# EQUIPMENT SUBMITTAL TRANSMITTAL

| Project:        | Meridian Data Centre Campus, Phase 1 | Spec Section: | 26 33 53       |

| Model Number    | Description                                         | Qty | Manufacturer           |
|-----------------|-----------------------------------------------------|-----|------------------------|
| VoltEdge BC-200 | VoltEdge BC-200 High-Rate VRLA Battery Cabinet Rack | 24  | VoltEdge Power Systems |

### Technical Parameter Specifications

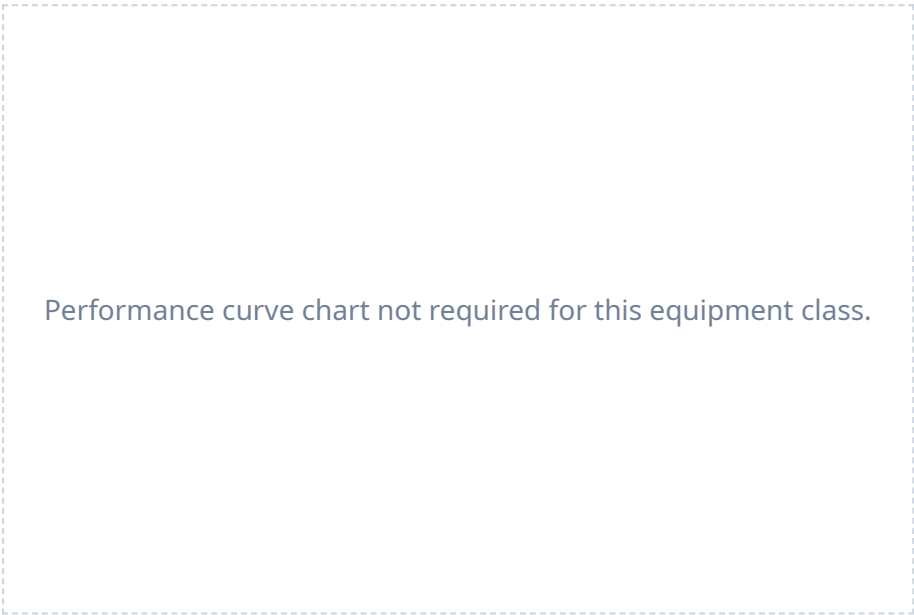
| Spec Clause                 | Parameter / Requirement | Conformance Claim | Remarks / Evidence                                                                                                                                                                                                                         |
|-----------------------------|-------------------------|-------------------|--------------------------------------------------------------------------------------------------------------------------------------------------------------------------------------------------------------------------------------------|
| 26 33 53<br>Part<br>2.3.2.A | BAT-CAPACITY-SHORTFALL  | NC                | Non-Conformant. Vendor datasheet claims nominal capacity is 550 kWh, which when converted ( $550,000 \text{ Wh} / 480 \text{ V} = 1145.8 \text{ Ah}$ ) is below the required 1200 Ah, indicating a capacity shortfall of 54.2 Ah (4.5%).   |
| 26 33 53<br>Part<br>2.3.2.A | BAT-CAPACITY-UNIT       | C                 | Conforms. Battery capacity is quoted as '576 kWh' in the submittal. Converting this ( $576,000 \text{ Wh} / 480 \text{ V} = 1200 \text{ Ah}$ ) matches the required capacity of 1200 Ah.                                                   |
| 26 33 53<br>Part<br>2.3.2.B | BAT-PF-CONDITION        | NC                | Non-Conformant. Datasheet claims 10-minute battery runtime is rated at a load power factor of 0.9 PF. The spec requires battery runtime to be rated at a load power factor of 1.0 PF (unity), which represents a larger active power draw. |
| 26 33 53<br>Part<br>2.3.2.C | BAT-DC-BUS-VOLTAGE      | NC                | Non-Conformant. Battery cabinet DC bus voltage is listed as 400 VDC. The spec requires a 480 VDC nominal bus voltage to match the UPS inverter requirements.                                                                               |
| 26 33 53<br>Part 2.3.3      | BAT-SHELF-LIFE          | NC                | Non-Conformant. The battery shelf life (required to be $\geq 6$ months without charge) is missing from the battery cabinet specification sheet.                                                                                            |
| 26 33 53<br>Part<br>2.3.5.A | BAT-CABINET-WEIGHT      | NC                | Non-Conformant. Fully loaded battery cabinet weight is listed as 3200 kg. Spec limits the maximum floor-load weight per cabinet to 2800 kg to prevent exceeding structural slab limits.                                                    |
| 26 33 53<br>Part<br>2.3.6.B | BAT-OPERATING-TEMP      | NC                | Non-Conformant. Battery cabinet datasheet lists operating temperature of 0°C to 20°C. Spec requires full battery warranty and operating parameters to hold from 0°C to 25°C ambient.                                                       |
| 26 33 53<br>Part 2.3.8      | BAT-CABLE-ENTRY         | NC                | Non-Conformant. Battery cabinet is configured for bottom cable entry only. Spec requires dual entry (top or bottom cable entry conduits) to match overhead cable trays.                                                                    |
| 26 33 53<br>Part<br>2.3.9.C | BAT-LVD-CONTACTOR       | NC                | Non-Conformant. Low Voltage Disconnect (LVD) contactor rating is omitted from the battery cabinet component details.                                                                                                                       |
